Cathedral Framing Detail

Reviewed by this office

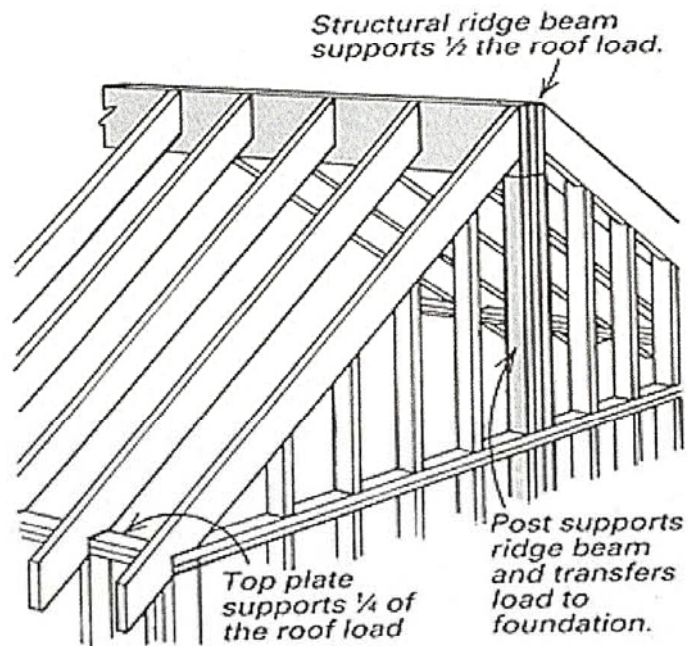
Lam Documents will be submitted once it is ordered and emailed to Code Enforcement.

Collar Ties will be Installed 18" Below Lam.
